RECEIVE AND FILE COMMUNICATION FROM THE PLAN AND ZONING COMMISSION REGARDING PRELIMINARY PLAT "GROVER WOODS" ON PROPERTY LOCATED AT 4500 HUBBELL AVENUE

Communication from the City Plan and Zoning Commission advising that at their meeting held December 5, 2019 the following action was taken regarding a request from Hubbell Realty Company (developer) represented by Eric Bohnenkamp (officer) for review and approval of a Preliminary Plat "Grover Woods" on property in the vicinity of 4500 Hubbell Avenue, to allow subdivision of the property into 84 single-family development lots. The subject property is owned by Baker Real Estate, LP.

PRELIMINARY PLAT FOR: GROVER WOODS DES MOINES, IOWA

TREE REMOVAL PLAN

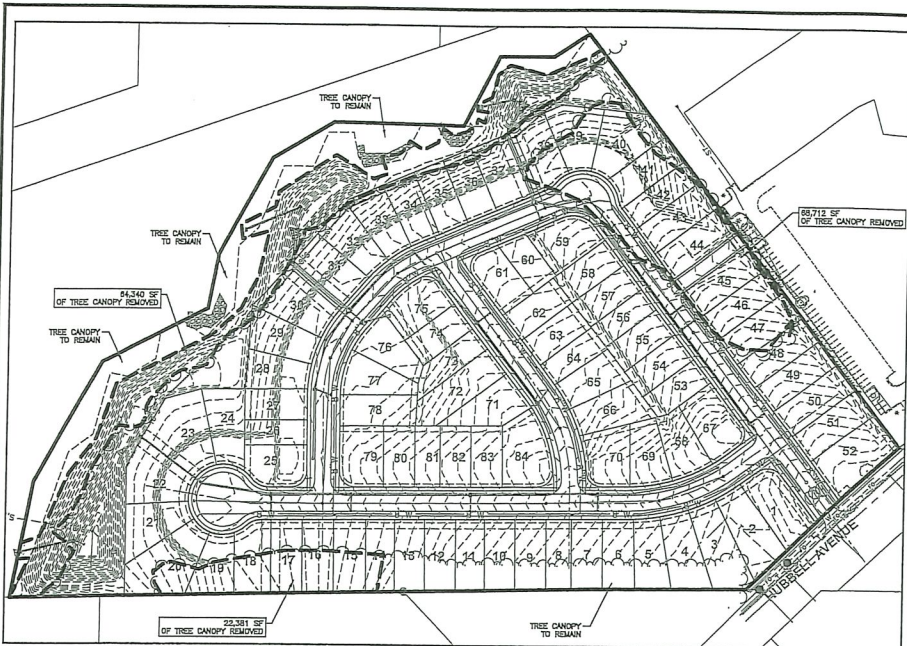
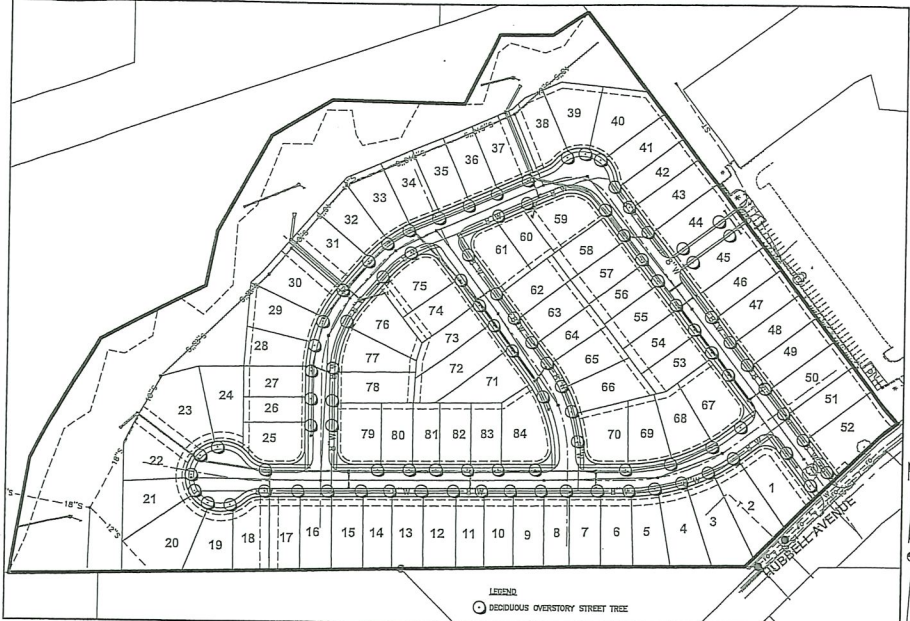
1. **Natural Features/Landscaping:** While the property is currently mostly tilled agricultural land, there are dense timbered areas to the northeast and northwest of the proposed amendment area. There is timbered fence line area on the southern edge of property. The PUD Conceptual Plan indicates that any tree removals resulting from the proposed development would require compliance with mitigation per the City’s Tree Removal and Mitigation Ordinance in Chapter 42, Article X of the City Code. This tree removal plan is

shown on Sheet 3 along with the proposed street tree plantings. There appears to be sufficient room to provide additional street trees on frontages for lots 25, 79, 75, 61, 59, 67, 84, and 70. Additional plantings are required per the PUD standards for private property as shown on Sheet 3.

3. Provision of 5-foot sidewalks along all public street sides of all lots, including a necessary public pedestrian easement for any walk which would need to be placed on private property.
4. Provision of additional street trees along the frontages of lots 25, 79, 75, 61, 59, 67, 84, and 70 to the satisfaction of the Permit and Development Administrator.
5. Provision of details on the Preliminary Plat describing the purpose of the outlot and maintenance responsibilities for Outlot "Y" to the satisfaction of the Permit and Development Administrator. (13-2020-1.18)
